FVA industry sub-group on technical requirements

15.11.2022

Summary for goals & next steps (1/2)

Coverage criterion

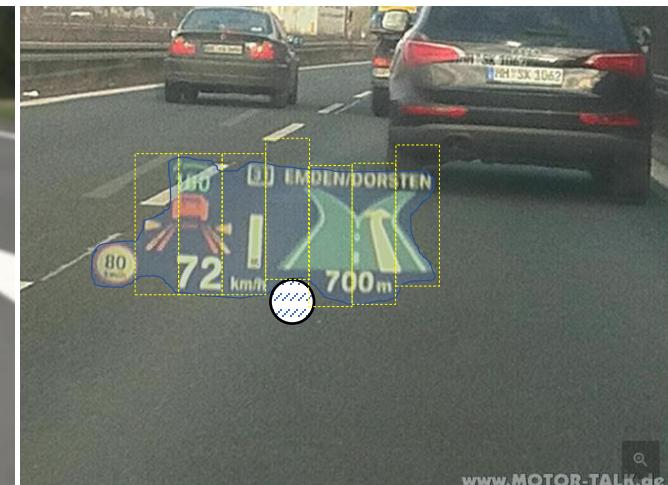
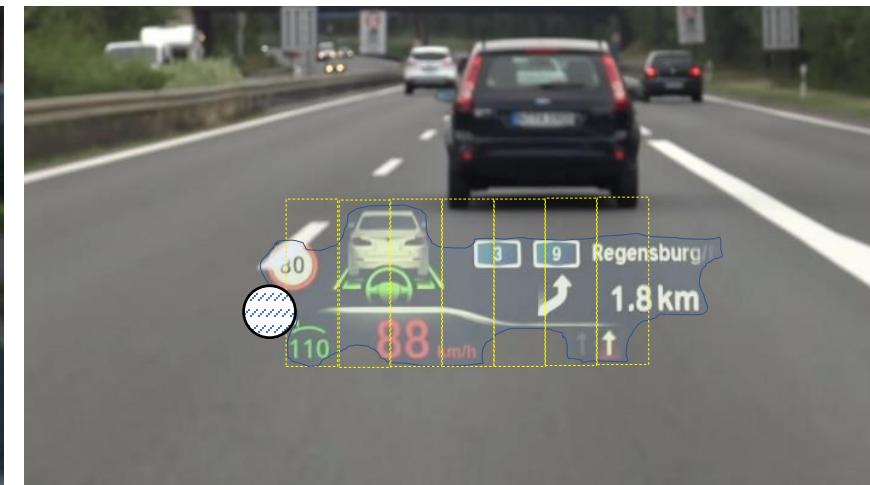
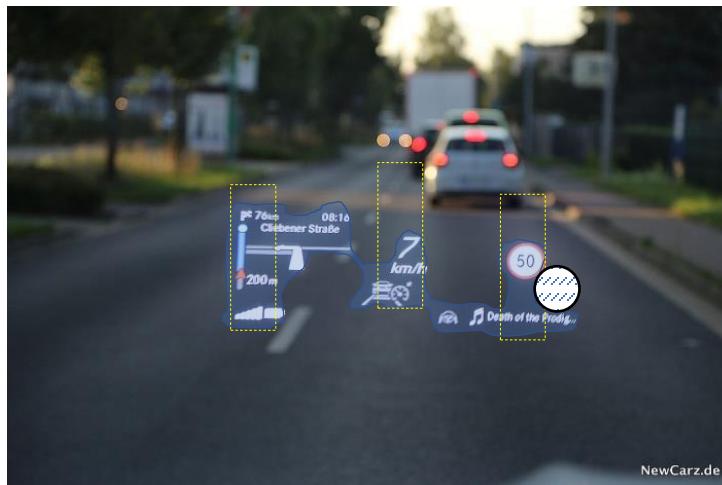
Example of series HUD in a situation where the car is standing in front of an inclining street

JAMA V4 violation examples of series HUD HMI #1

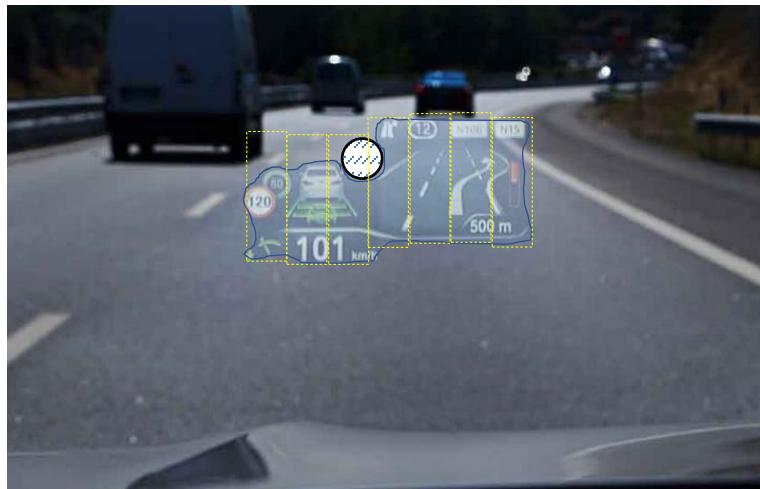
violating JAMA V4 envelope (3x)

violating JAMA V4 envelope (7x)

JAMA V4 violation examples of series HUD HMI #2

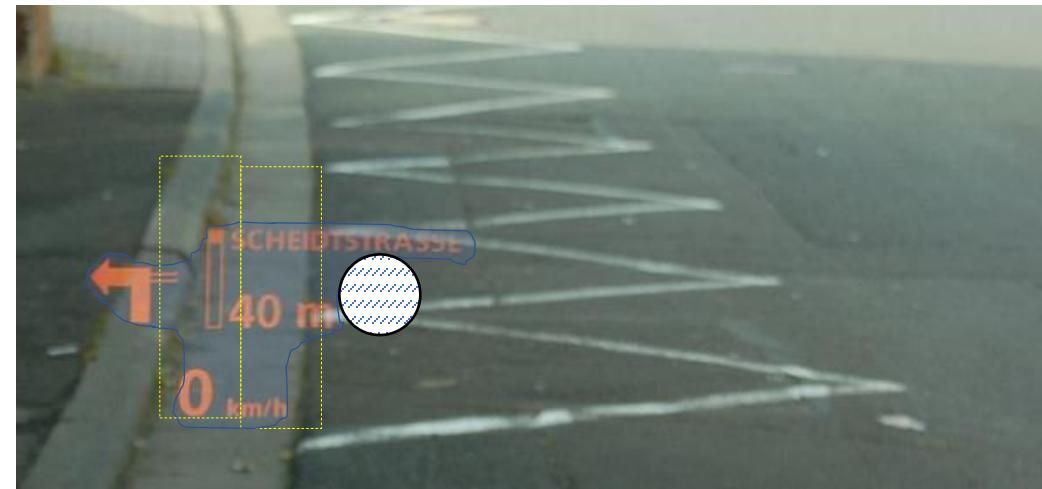
violating JAMA V4 envelope (7x)
violating JAMA V4 red criteria

violating JAMA V4 envelope (2x)
violating JAMA V4 red criteria

no-go test pictures as a first shot for coverage

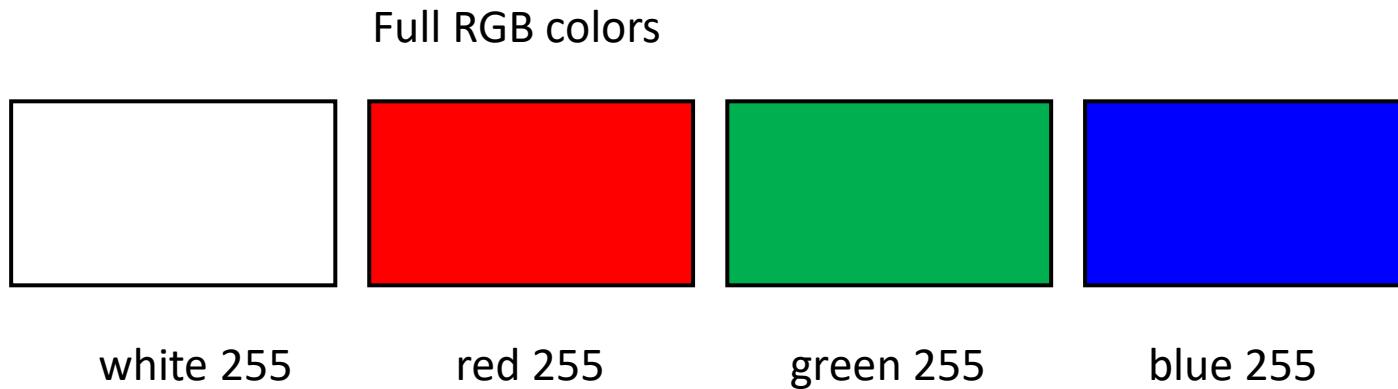
...must be prevented by the FVA system itself

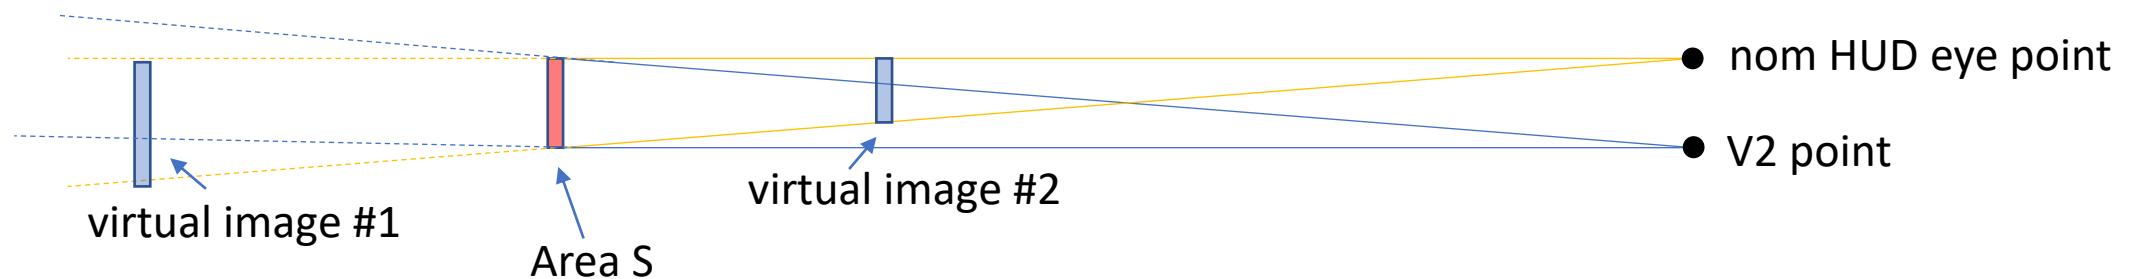
While it is true that the image of a system with lower VID appears higher from V2 point, the behavior of the system when seen from the actual eye point is different. This is happening due to a parallax error.

The following image shows the principle of that effect:

Area S vs. V2 point vs virtual image distance

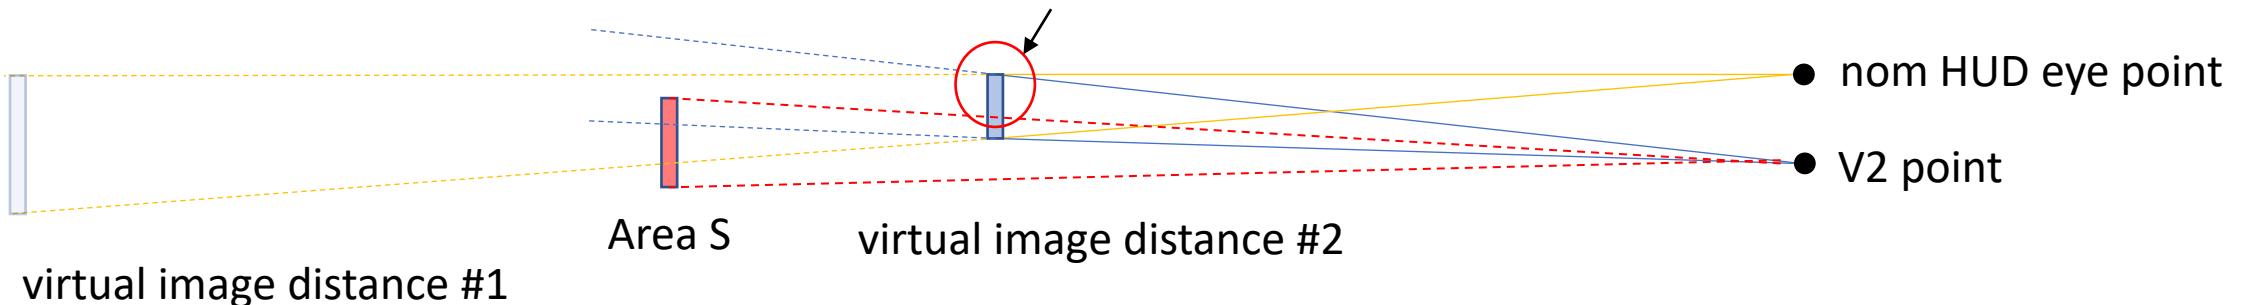
Case 1 & 2: Situation in two HUD systems with **identical** look-down-angles and different VID's:

CASE 1: large VID

CASE 2: small VID

Small VID: 2/3 of VI regulated as FVA (VI is inside and above Area S when seen from V2)

Area S vs. V2 point vs virtual image distance

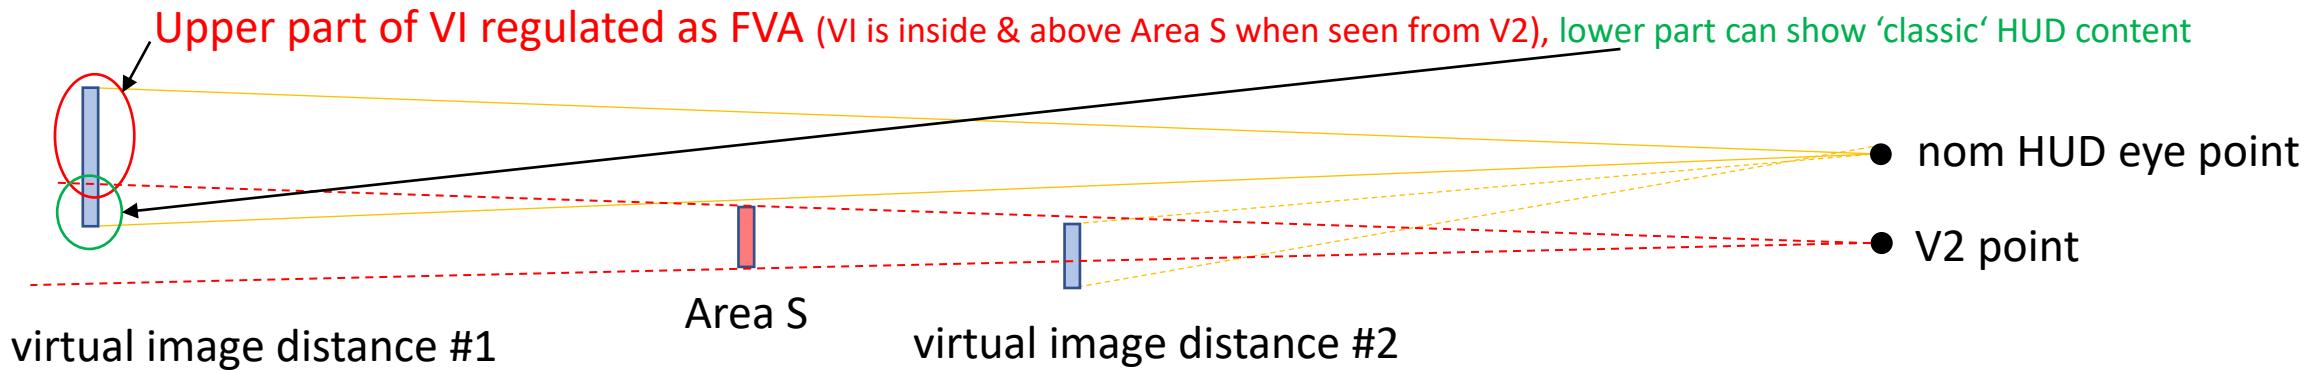
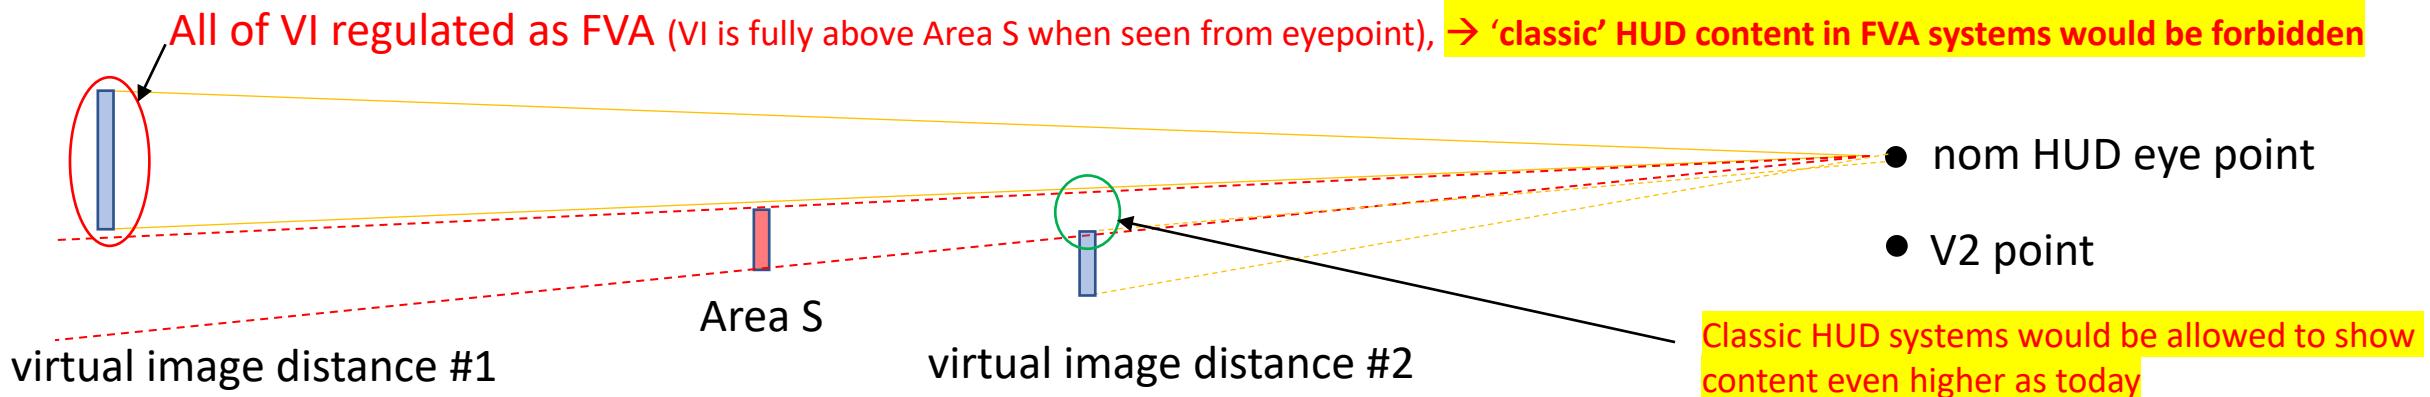
FVA systems typically have a larger VID and less lookdown angle (LD is about -2.5° instead of about -5° for classic HUD systems)

CASE 3: large VID, less LD angle (typical FVA system), investigated from V2 point (current regulation)

CASE 4: large VID, less LD angle (typical FVA system), but investigated from eyepoint instead of V2

Conclusion: Keep the requirement to calculate from V2 point (as currently defined), considering that the parallax error will happen for any object that is not exactly in the same plane (i.e. same distance) as Area S.

This ensures that no potential for worsening classic HUD systems is possible and at the same time keeps the possibility to show classic HUD content (static symbols) within FVA systems in the lower area.

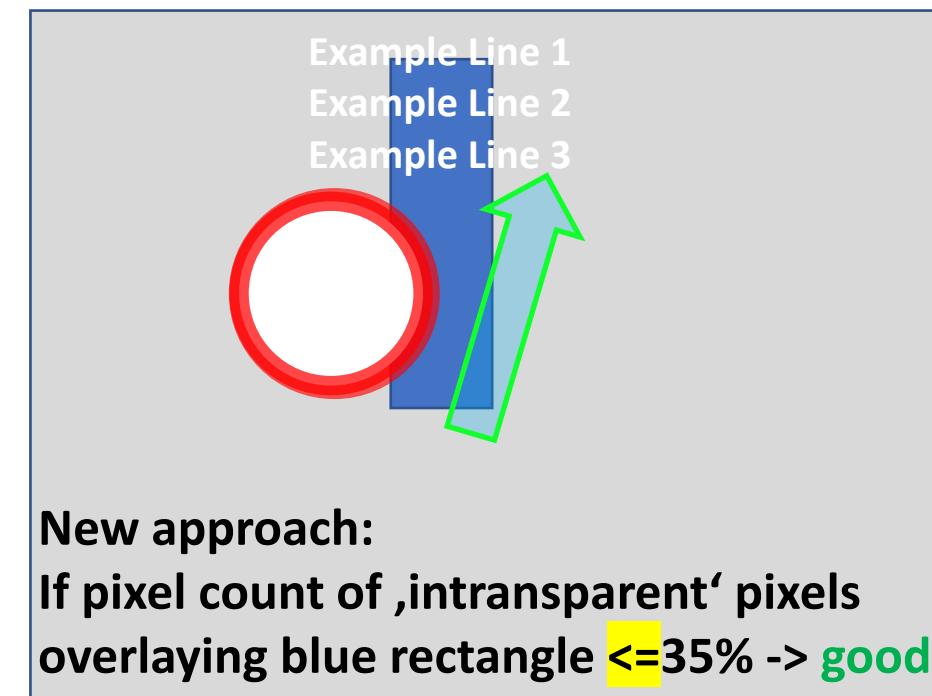
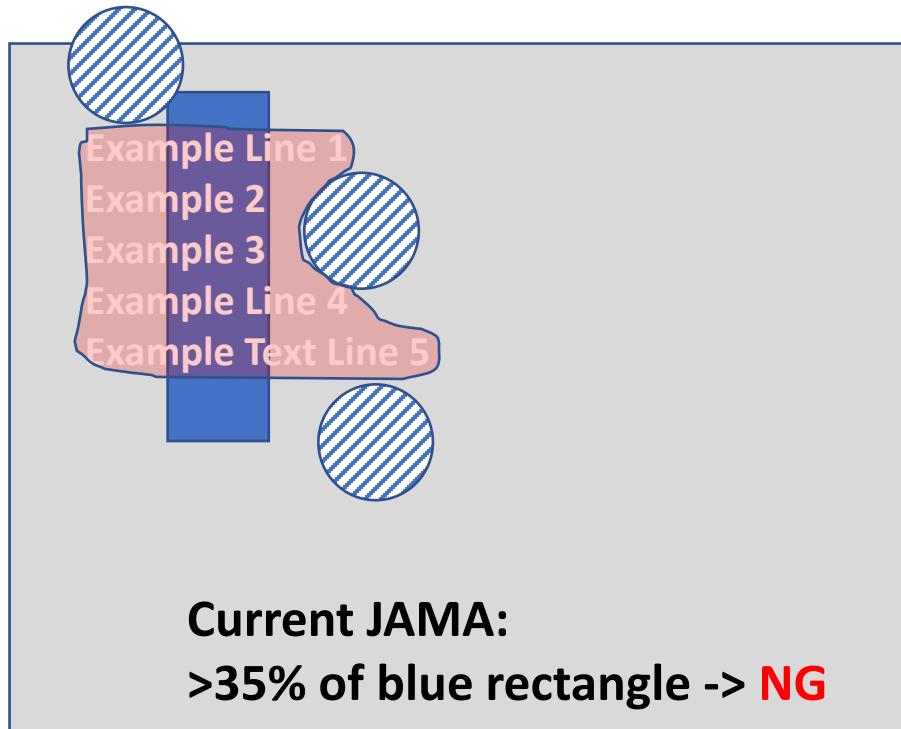
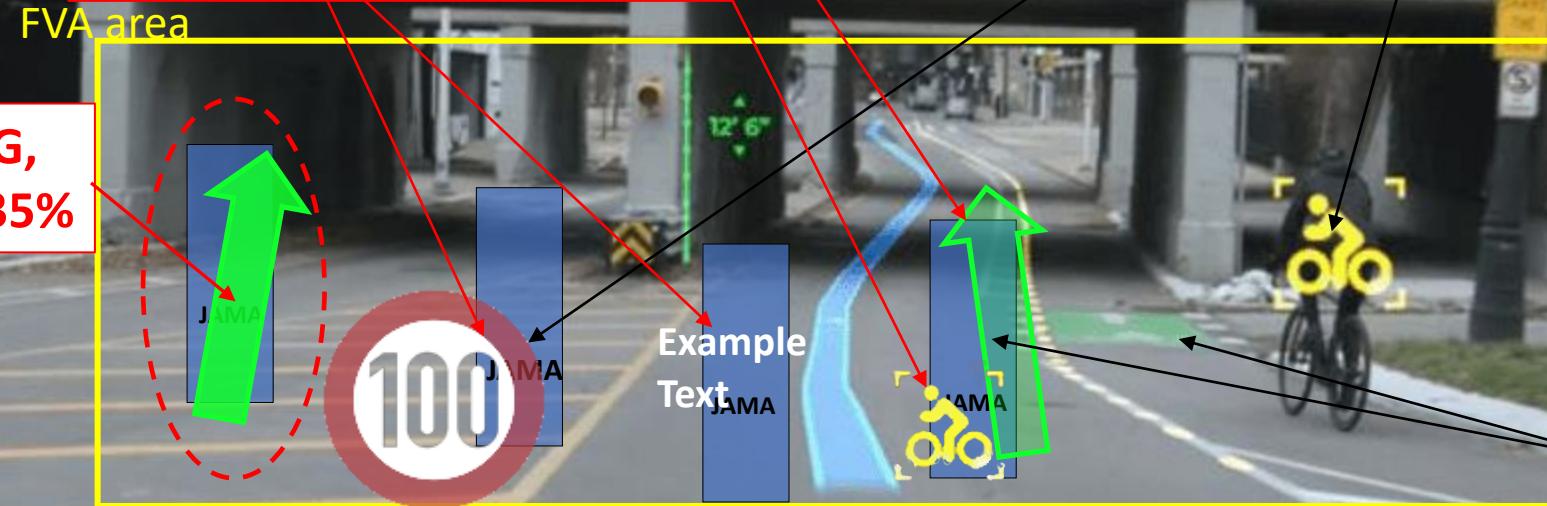
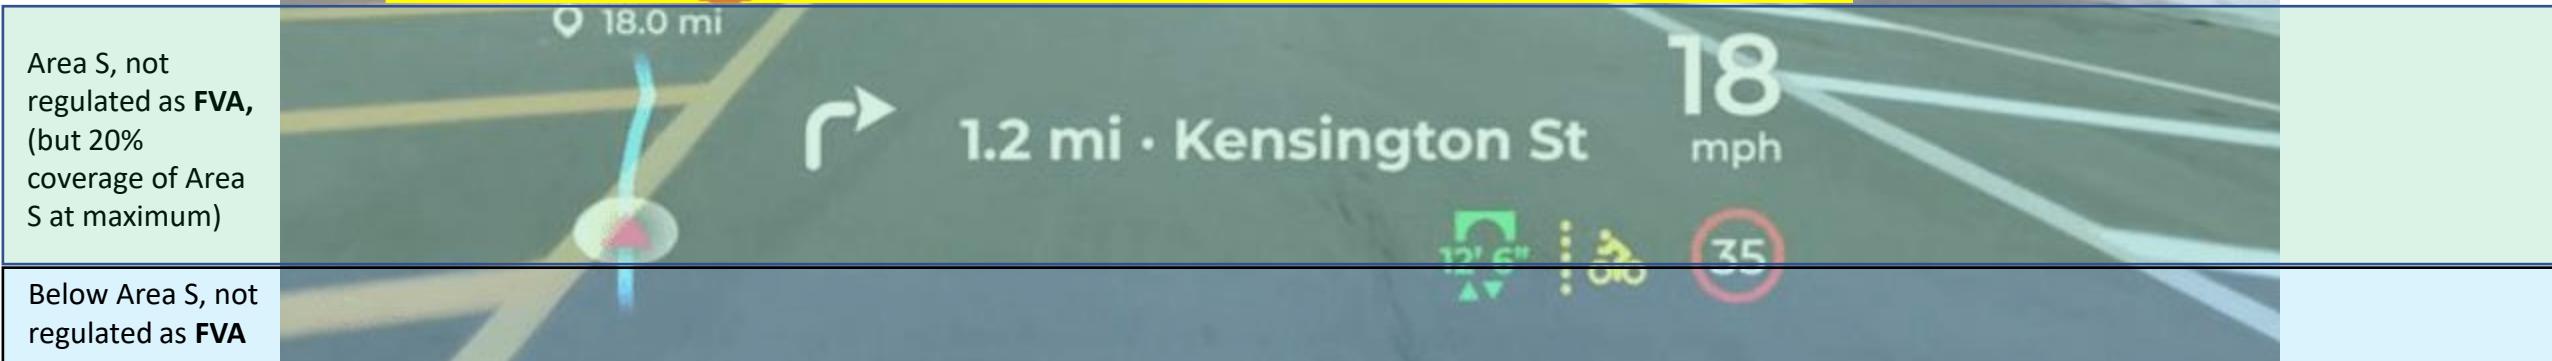
To discuss: e.g. 35% of full FVA area could still allow a relatively large area of connected pixels, so maybe some measure to prevent large connected areas must be taken by the OEM. **As an example only** the JAMA approach of the cylinder that resembles a pedestrian, or any other measure that prevents large connected pixel areas:

counting as „possibly covering“ of the blue „JAMA rectangles“ because full brightness for given situation and color strongly perceived by human eye (e.g. white, green)

- Bright green outline of arrow
- Full brightness symbols that are **not augmented** onto the object
- White pixels in speed sign and texts

Not counting as „possibly covering“ although full brightness for given situation:

- colors that seem semi-transparent due to color perception of human eye
- **augmented** image content that is highlighting something

Not counting as „possibly covering“ because the reduced brightness in comparison to allowed max. brightness for this outside light condition results in semi-transparent perception

New approach for discussion: If pixel count of „possibly covering“ pixels overlaying each blue „JAMA rectangle“ in FVA area $\leq 35\%$ -> good

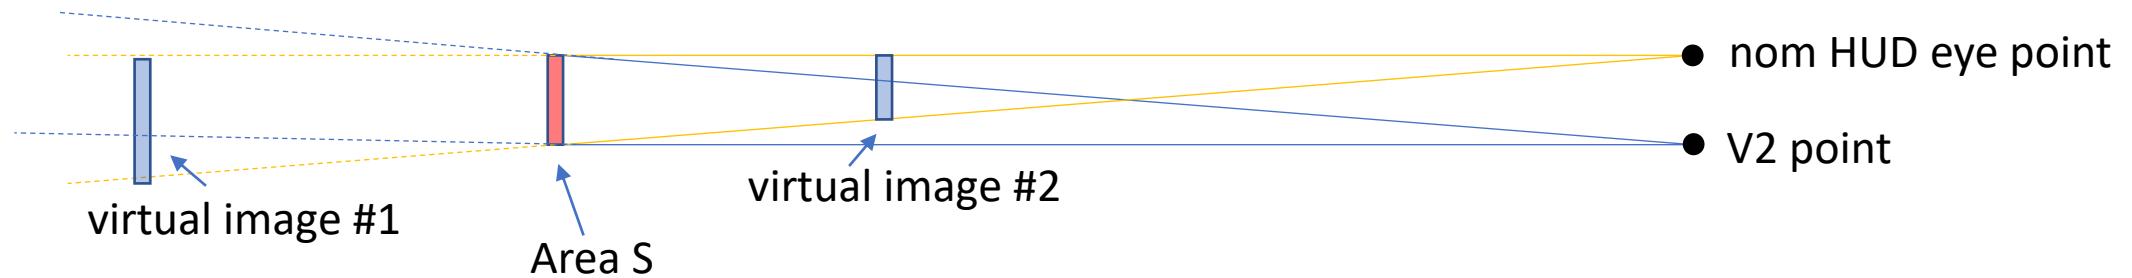
While it is true that the image of a system with lower VID appears higher from V2 point, the behavior of the system when seen from the actual eye point is different. This is happening due to a parallax error.

The following image shows the principle of that effect:
